**TECHNICAL MEMORANDUM NO. 1
SUPPLEMENTAL BASIS OF DESIGN - RESPONSE TO ECRB COMMENTS**

SUBJECT: Terminal 1, Latitude Project – Response to ECRB Comments

Reference: ENGEO; Existing Geotechnical Conditions and Seismic Slope Stability, Terminal One, Richmond, California; July 24, 2017; Project No. 5931.000.000

Exhibit 1: N versus Phi (Peck, Hanson, and Thornburn)

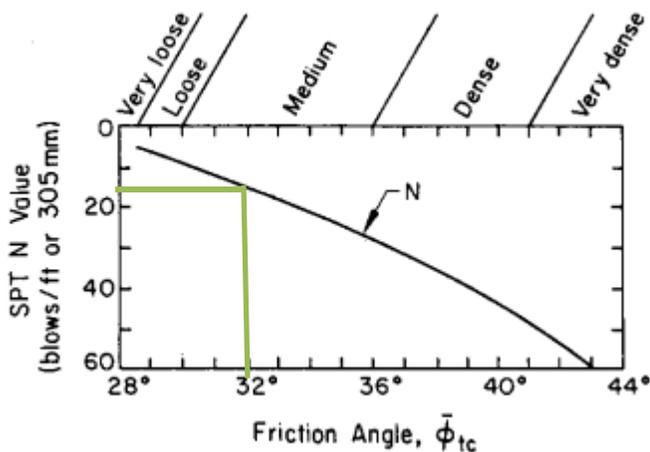
ECRB Comment #2:

Questions were raised regarding the strength parameters used in evaluating the stability of the sand and clayey sand using ϕ of 30 degrees and a c of 730 psf.

Based on correlations between N_{60} and friction angle by Peck, Hanson, and Thornburn, we conservatively assigned the *sand with clay* layer a friction angle of 30 degrees. As shown below, based on a blow count of 16, a higher friction angle would be reasonable.

PROJECT NO.: 5931.000.000	FIGURE NO.
SCALE: AS SHOWN	1
DRAWN BY: JCS CHECKED BY: JAF

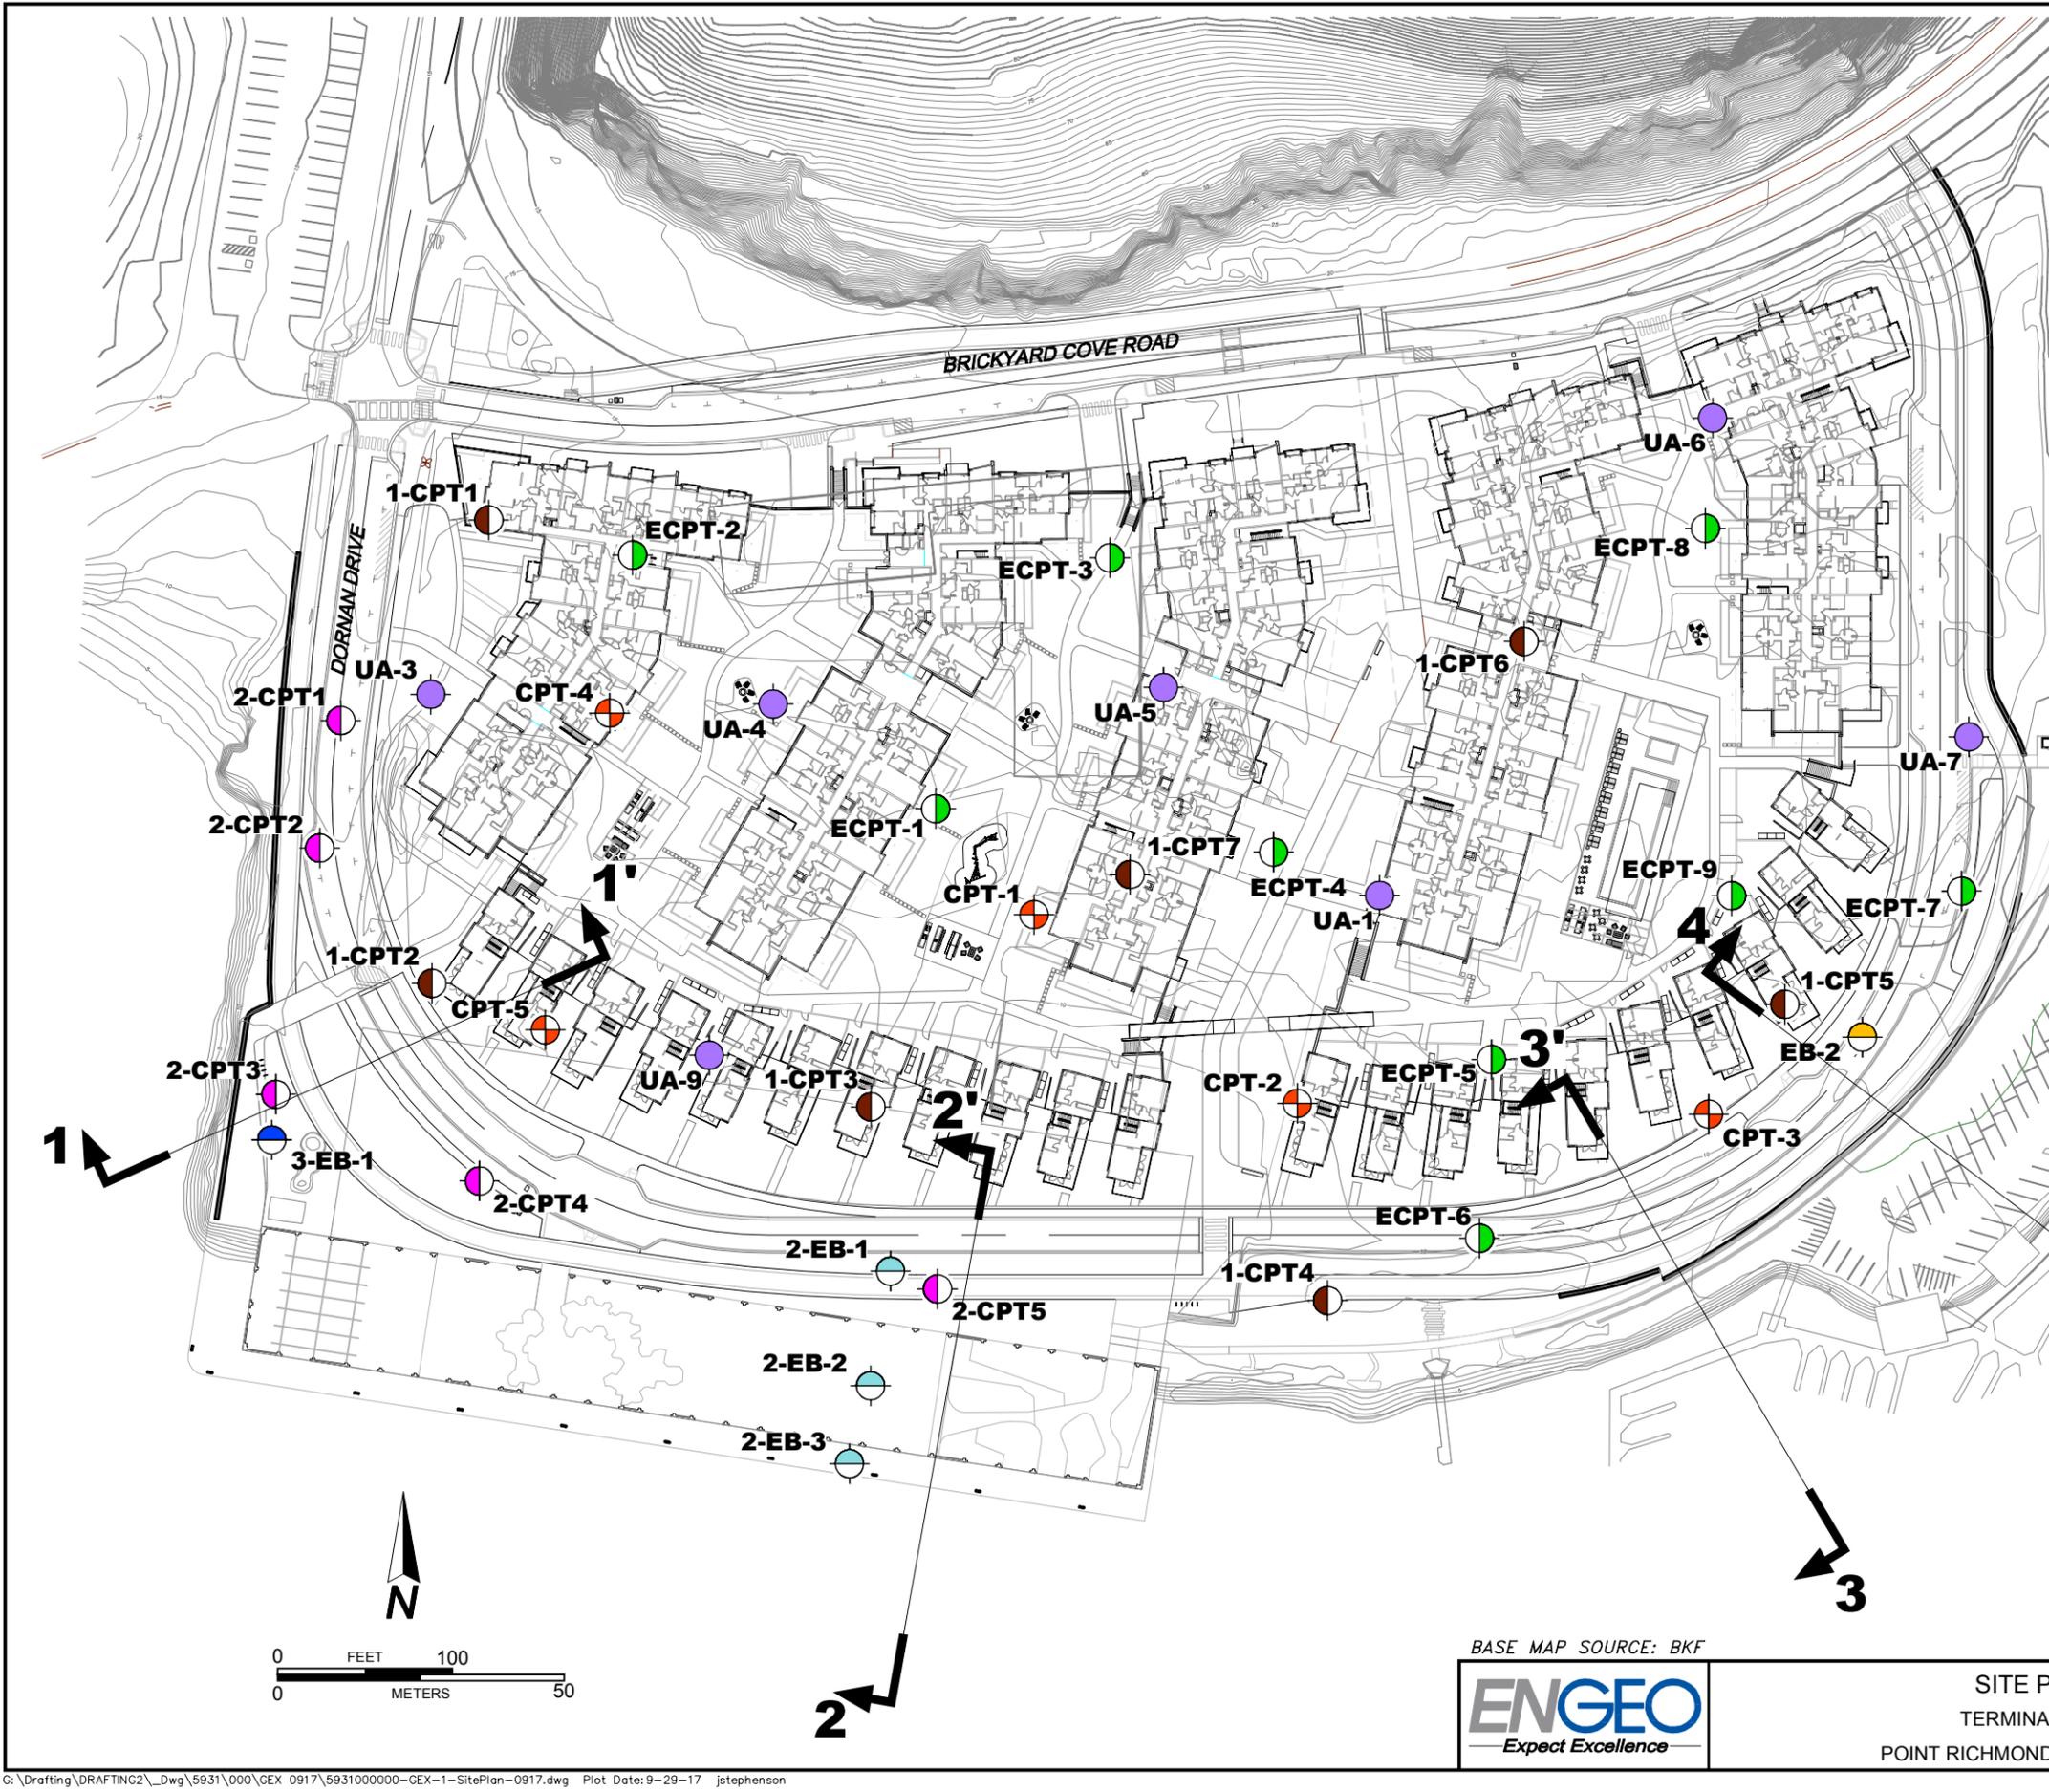
ECRB Comment #1:

Look at the amount of information gathered on the western part of the site to see if additional work and exploration is warranted to better characterize the materials below the Bay mud.

As requested by the ECRB, we reviewed the site exploration data for the western portion of the Terminal One site. Based on this review, we performed an additional subsurface exploration in the vicinity of the southwest corner of the site, shown on Figure 1, denoted as 3-EB-1 (Attachment C). The boring log for this boring is attached. Figure 3 shows the locations of three cross-sections along the existing shoreline that illustrate the relative consistency in subsurface conditions. We discuss our findings in our response to ECRB Comment #5 below.

FIGURE NO.
3

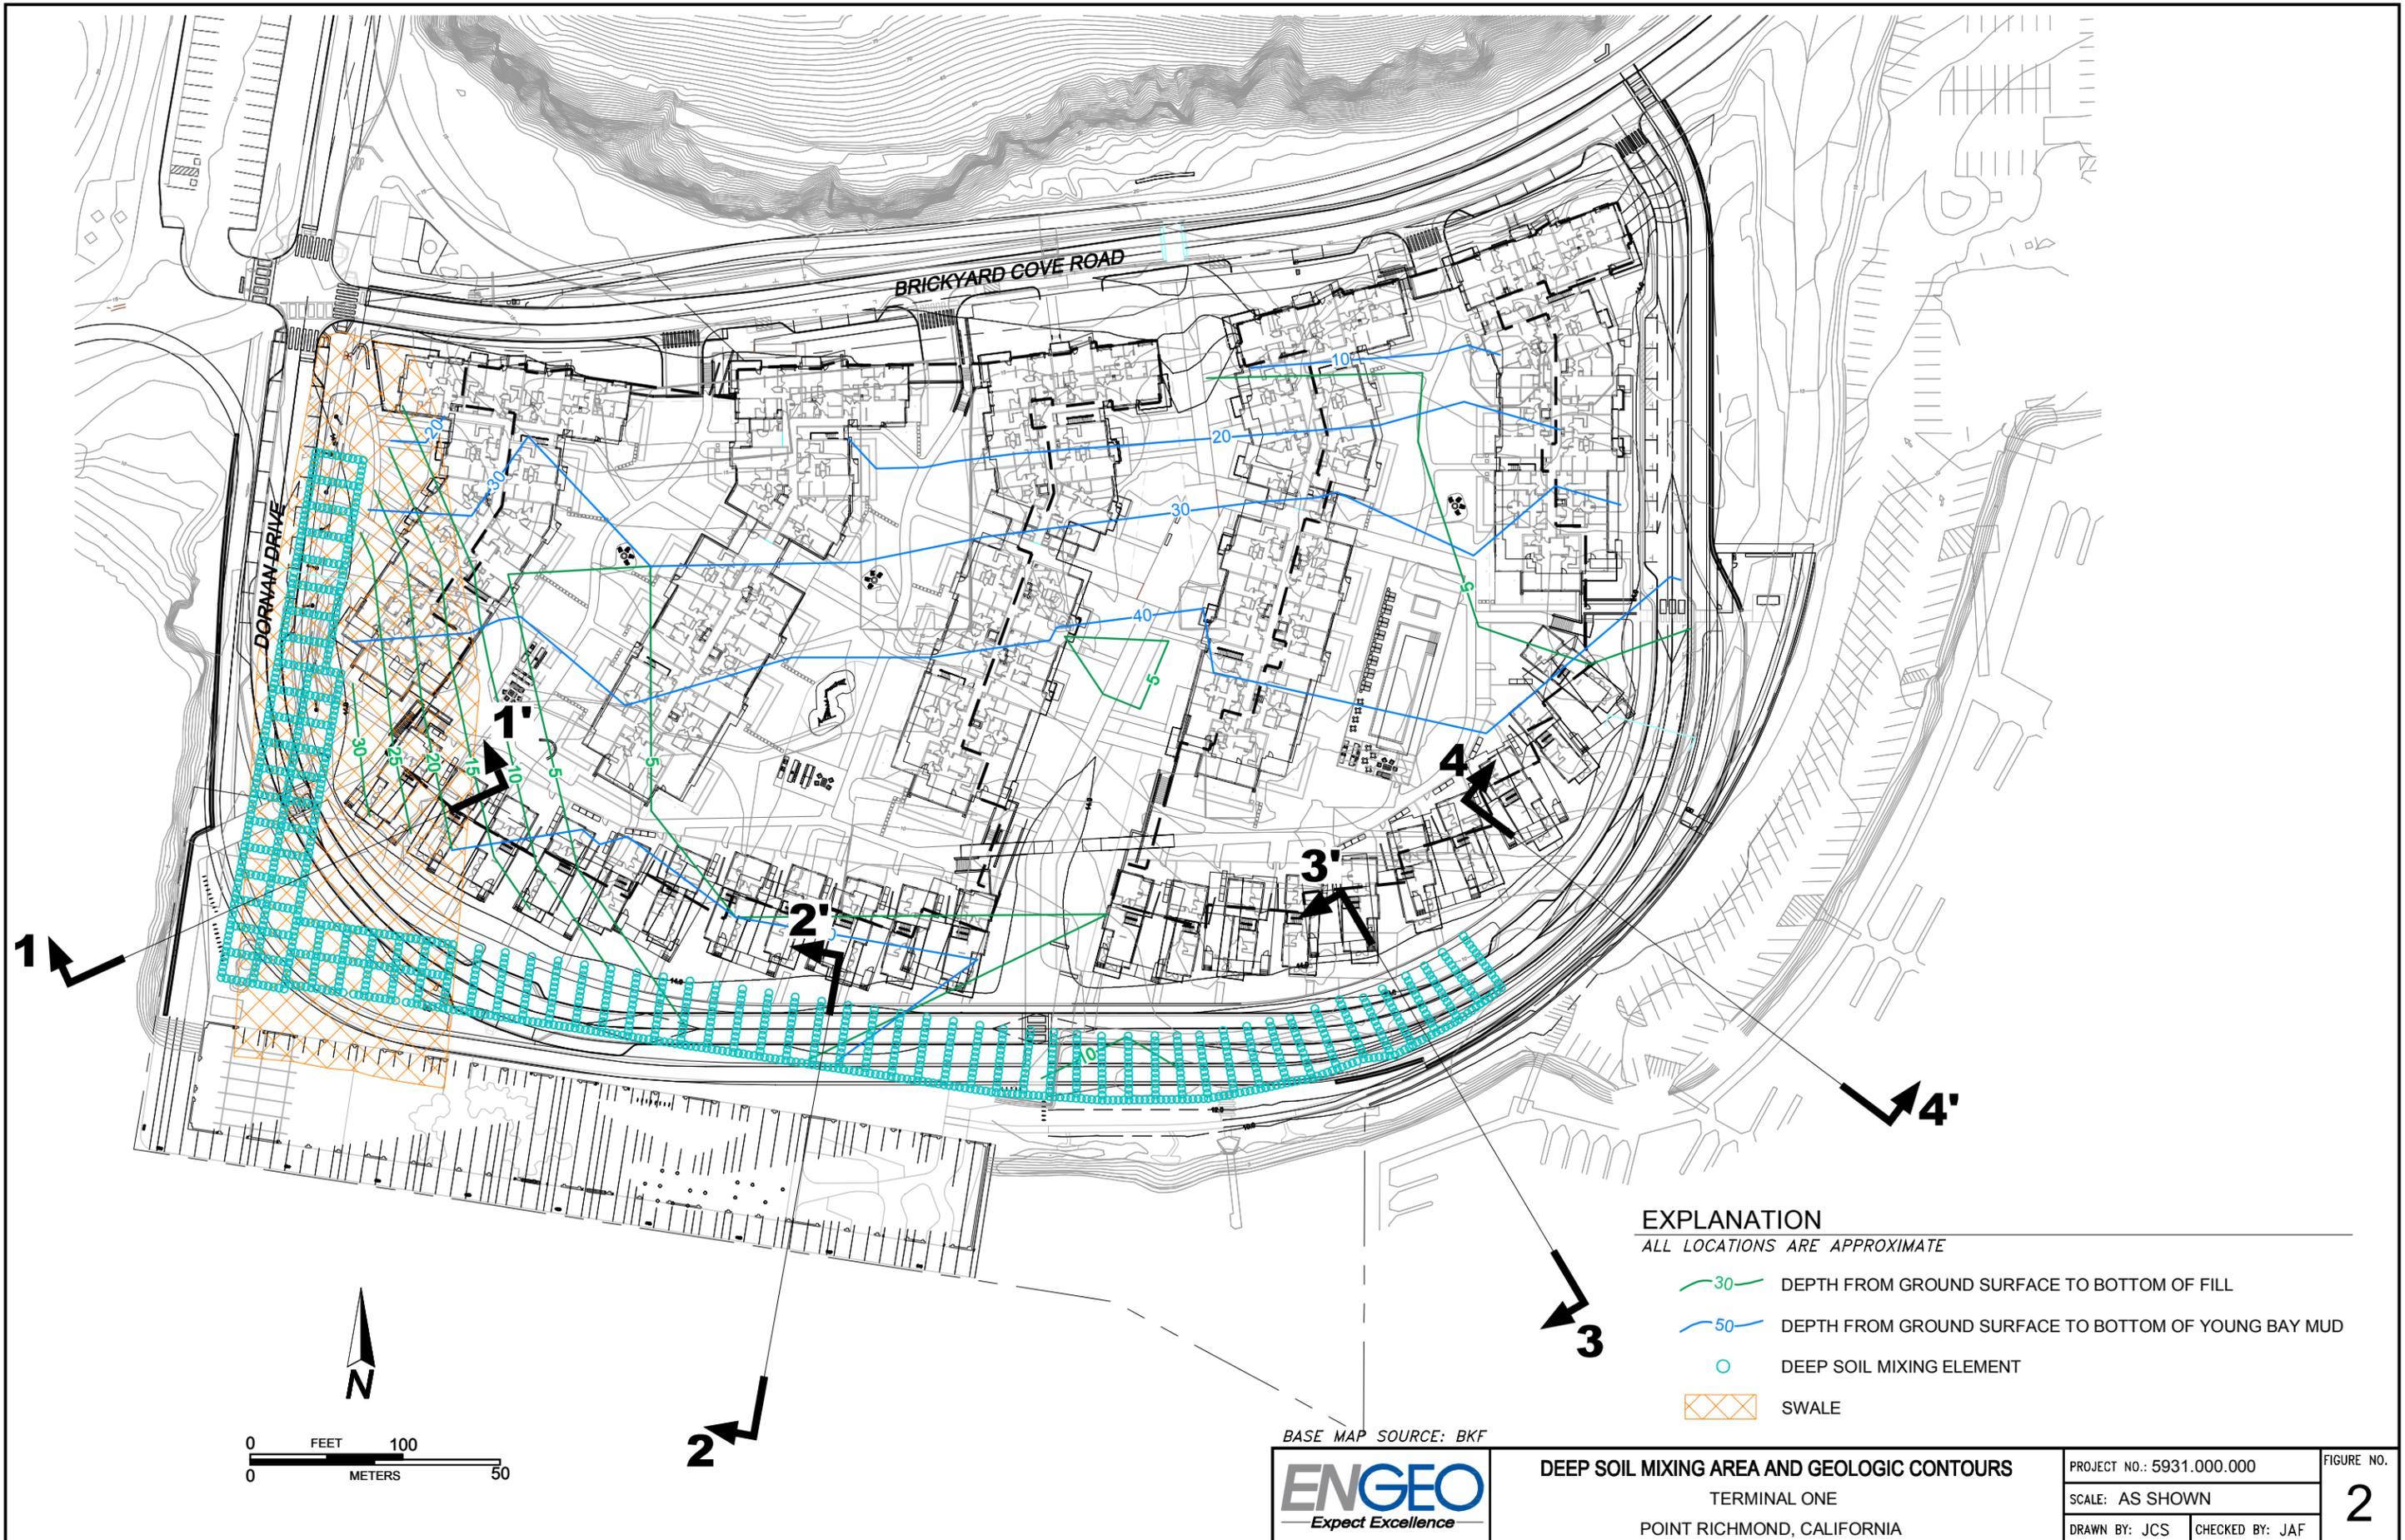
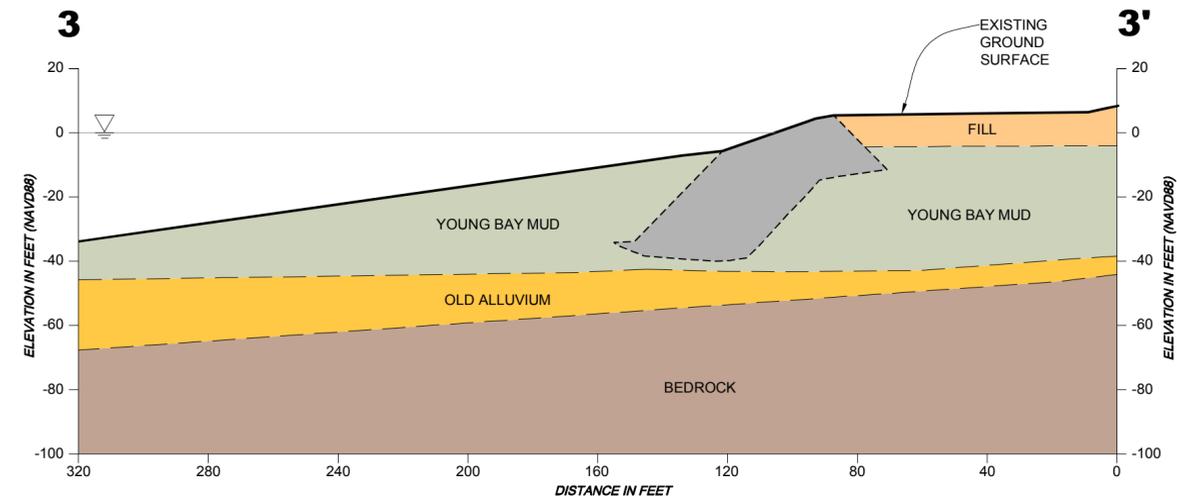
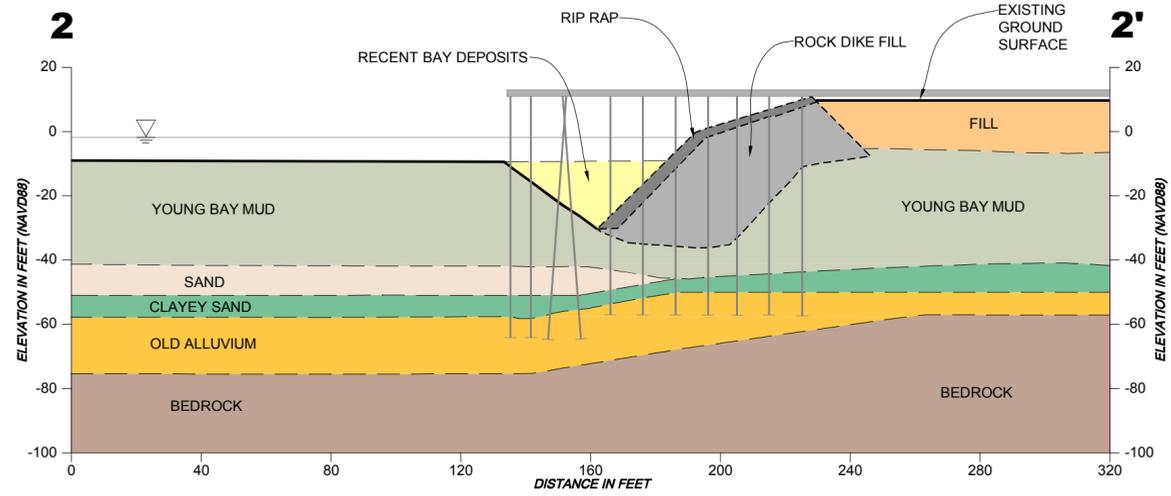
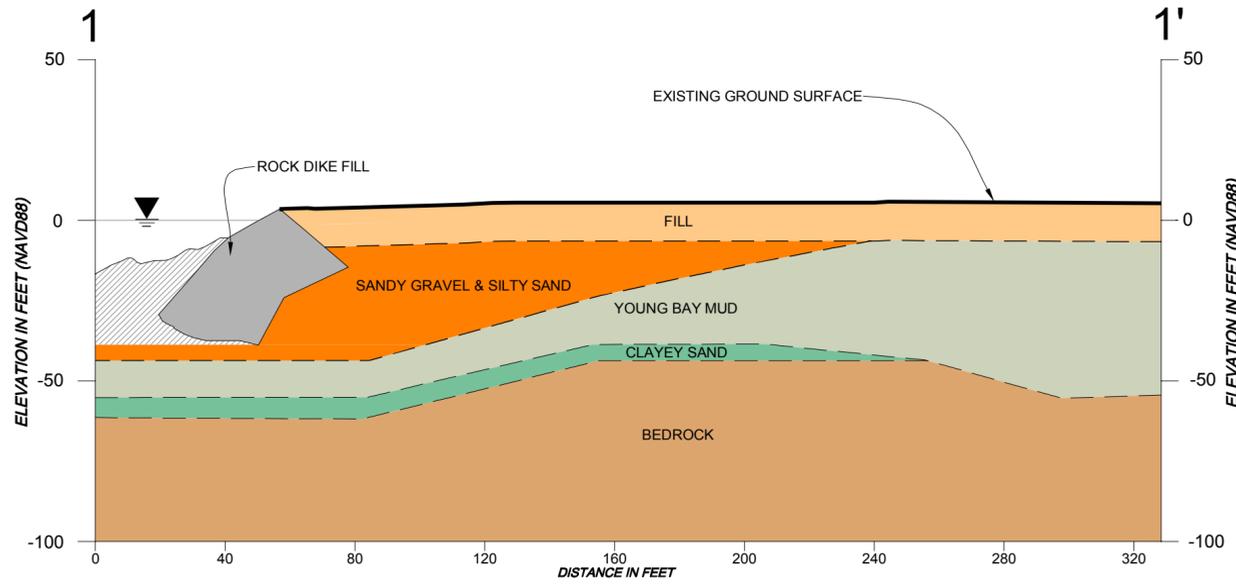
ECRB Comment #5:

Provide information gathered regarding subsurface profiles in other parts of the site, including longitudinally.

While the majority of our slope stability study presented in the reviewed report related to the southern shoreline underlying the wharf, we also considered the stability along the western edge of the site as well as east of the wharf. Improvements along the western shoreline and east of the wharf include a section of the Bay Shore Trail and a portion of Dornan Drive. Figures 1 and 2 illustrate the locations of the other cross sections we considered. All of the cross-sections are shown on Figure 3.

Given the similar soil types and thicknesses within the various sections, we anticipate similar seismic performance across the shoreline. Based on the seismic slope stability analysis we performed on Section 2-2' beneath the wharf and by inspection of the other cross-sections, we recommended the DSM buttress as a mitigation along the entire perimeter of the site. The DSM will abut the back of the rock dike and likely have a 1:1 depth to width ratio, and terminate a minimum of 5 feet below the bottom of the Young Bay Mud.

The silty sand shown on Section 1-1' is fill material within an historic swale which we have identified as potentially liquefiable. As such, we recommended that a closed grid of deep soil mixing (DSM) elements be constructed along the western shoreline.
